# UNITED STATES PATENT AND TRADEMARK OFFICE

APPLICATION NO.	FILING DATE	FIRST NAMED INVENTOR	ATTORNEY DOCKET NO.	CONFIRMATION NO.
10/814,610	03/30/2004	Darin G. Schaeffer	8627-190	5422
757 7590 07/19/2007 BRINKS HOFER GILSON & LIONE P.O. BOX 10395 CHICAGO, IL 60610			EXAMINER MILLER, CHERYL L	
			ART UNIT 3738	PAPER NUMBER
			MAIL DATE 07/19/2007	DELIVERY MODE PAPER

<b>Office Action Summary</b>	Application No. 10/814,610	Applicant(s) SCHAEFFER, DARIN G.	
	Examiner Cheryl Miller	Art Unit 3738

# Attachment # 1 (marked up) claims 23-30

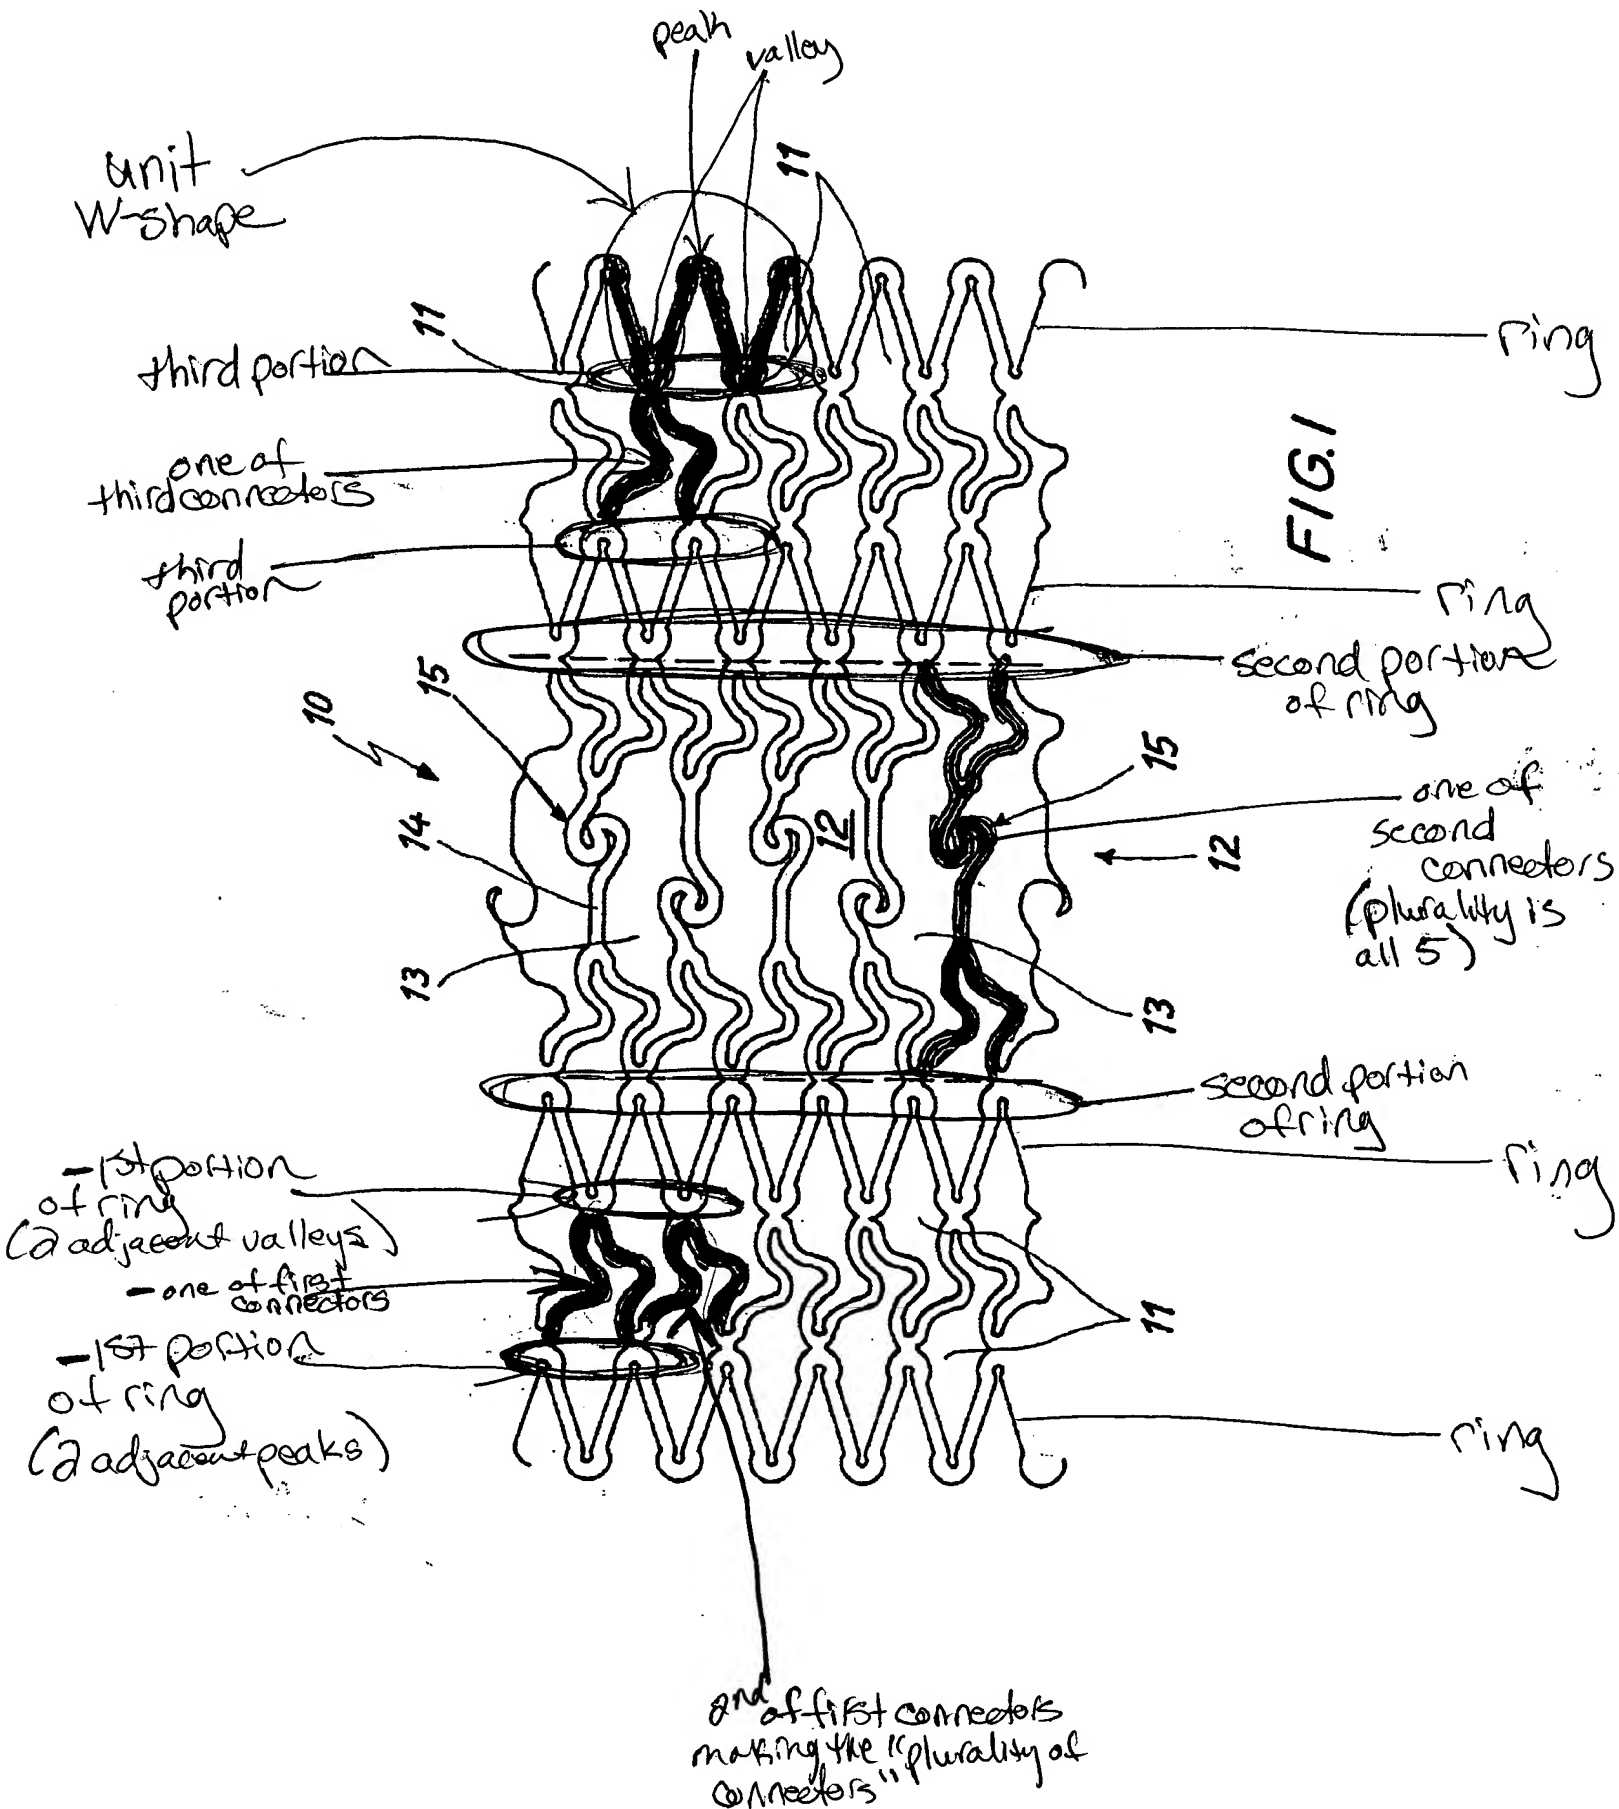
Claims 23-30 are rejected under 35 U.S.C. 102(b) as being anticipated by Von Oepen et al. (EP 0 958 794 A2, cited in IDS, see US 6,652,573 B2 for English equivalent). Von Oepen discloses a stent (10; fig.1) comprising a series of rings forming serpentine patterns and comprising a plurality of units, the units comprising first and second lateral arms and a central region between the arms, the central region having a peak between two valleys, each unit inverted with respect to the circumferentially adjacent unit, the lateral arms of each unit shared, a first portion of the rings (2 adjacent peaks of a ring considered the “first portion”, see attachment 1) being joined by a first plurality of connectors (“plurality of connectors” considered 2 adjacent connectors, highlighted in attachment 1) having an undulation, a second portion of the rings (all five peaks of one ring) joined by a second plurality of connectors (all five 14+15 connectors seen in fig.1) having an undulation (15), a third portion of the rings (2 adjacent peaks of one ring)

joined by a third plurality of connectors (2 adjacent connectors) having an undulation, wherein the undulation of the second connector (15) is axially displaced from its circumferentially adjacent connector (15) and an undulation of the first and third connectors axially aligned with circumferentially adjacent connectors (see attachment 1, fig.1). Von Oepen discloses the second connectors (15; 5 of them in number) to be double in number to the first and third connectors (only 2 of each the first and third connectors are considered the “plurality of connectors”), therefore, there are double the amount of second connectors). Von Oepen discloses the units to comprise a W-shape (see attachment 1). Von Oepen discloses the undulation of the connectors to be a u shaped bend flanked with u bends (see fig.1).

## US 6,352,552 B1

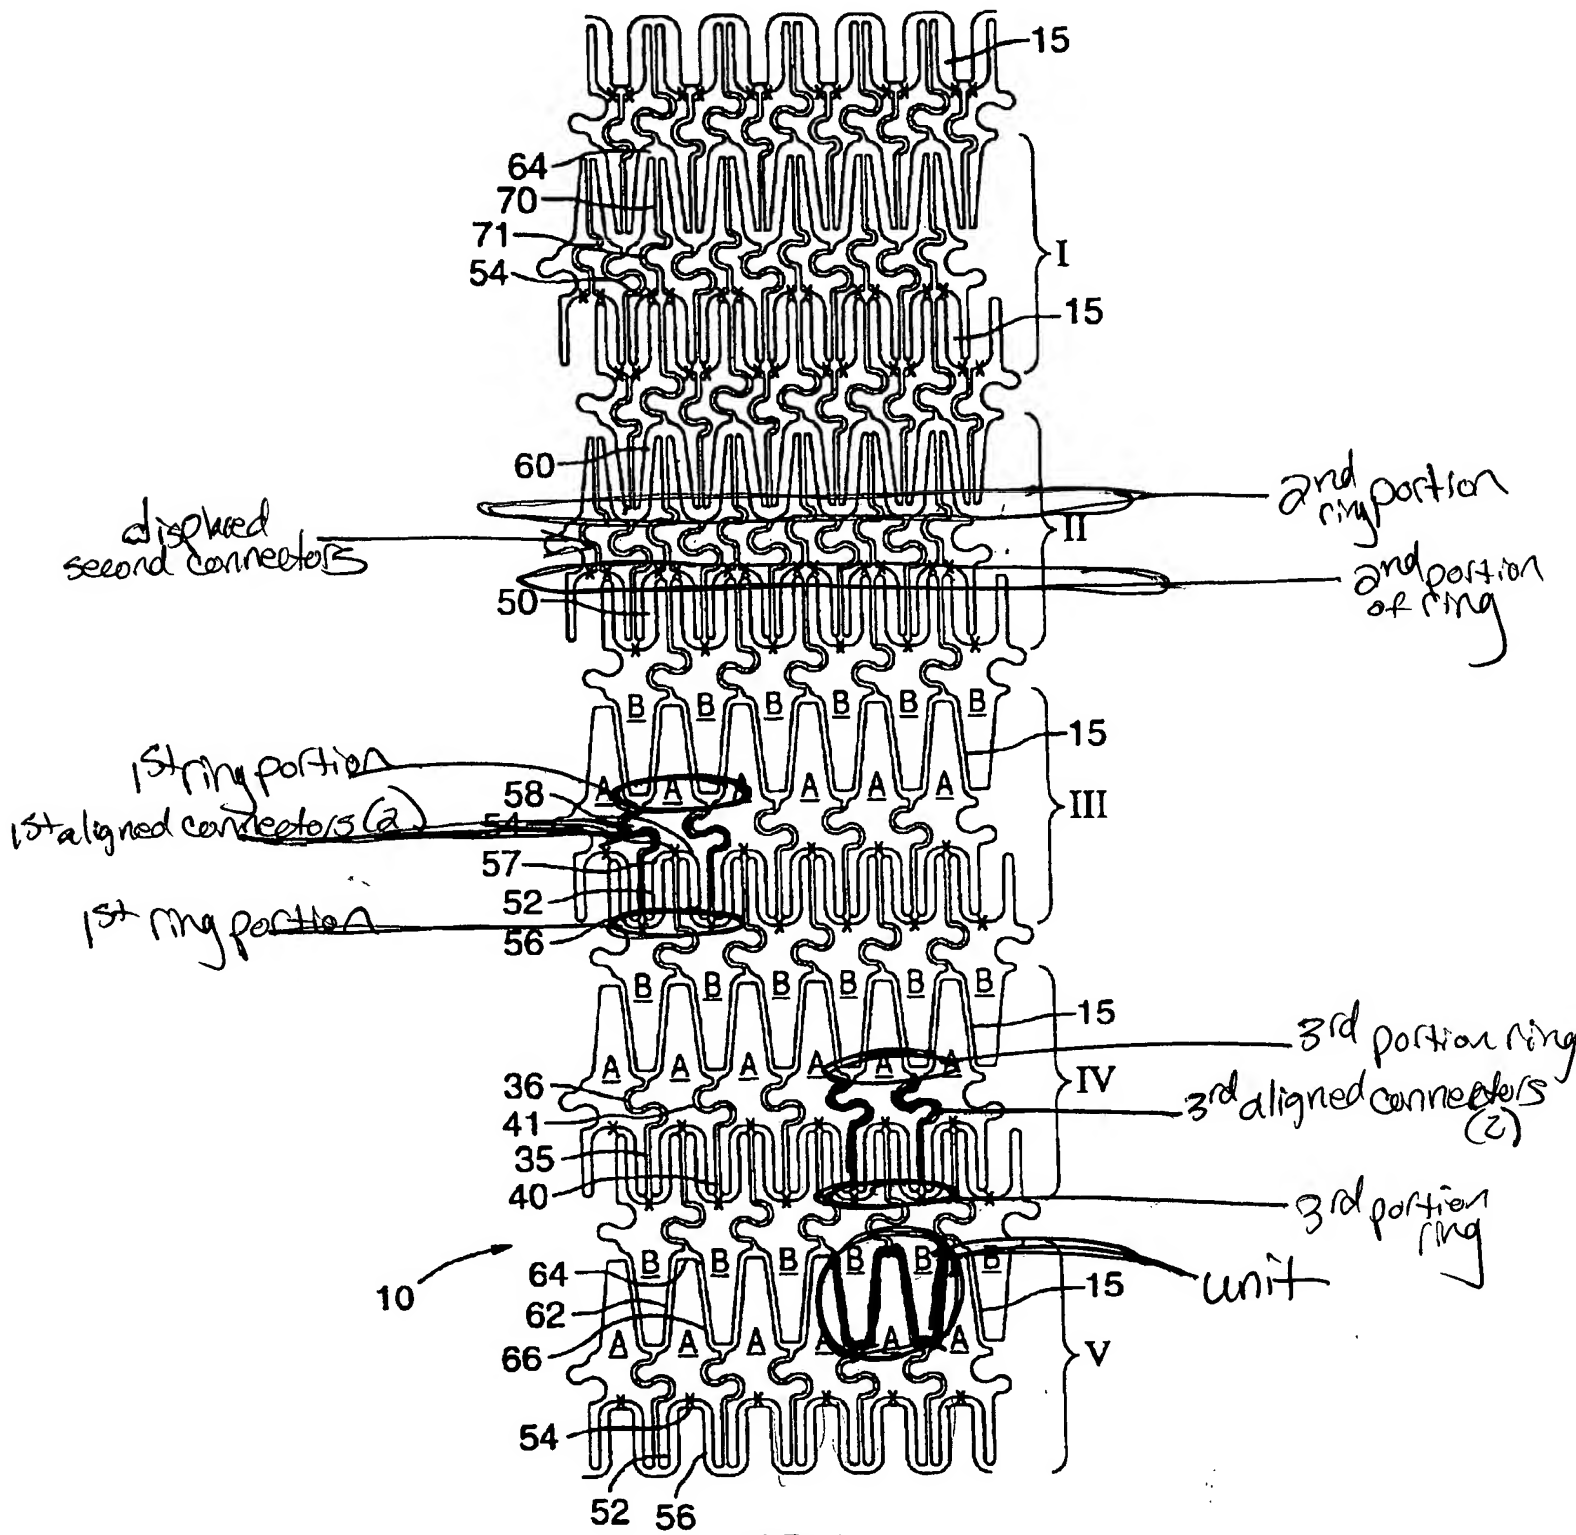
Claims 23-30 are rejected under 35 U.S.C. 102(e) as being anticipated by Levinson et al. (US 6,352,552 B1, cited previously). Levinson discloses a stent (20; fig.1) comprising a series of rings forming serpentine patterns and comprising a plurality of units, the units comprising first and second lateral arms and a central region between the arms, the central region having a peak between two valleys, each unit inverted with respect to the circumferentially adjacent unit, the lateral arms of each unit shared, a first portion of the rings (2 adjacent peaks of a ring considered the “first portion”, see attachment 2) being joined by a first plurality of connectors (“plurality of connectors” considered 2 adjacent connectors, highlighted in attachment 2) having an undulation (72), a second portion of the rings (all six peaks of one ring) joined by a second plurality of connectors (all six displaced connectors seen in fig.1) having an undulation, a third portion of the rings (2 adjacent peaks of one ring) joined by a third plurality of connectors (2 adjacent connectors 96, 98) having an undulation, wherein the undulation of the second connector is

axially displaced from its circumferentially adjacent connector and an undulation of the first and third connectors axially aligned with circumferentially adjacent connectors (see attachment 2, fig.1). Levinson discloses the second connectors (6 of them in number) to be double in number to the first and third connectors (only 2 of each the first and third connectors are considered the “plurality of connectors”, therefore, there are double the amount of second connectors). Levinson discloses the units to comprise a W-shape (see attachment 2). Levinson discloses the undulation of the connectors to be a u shaped bend flanked with u bends (see fig.1).
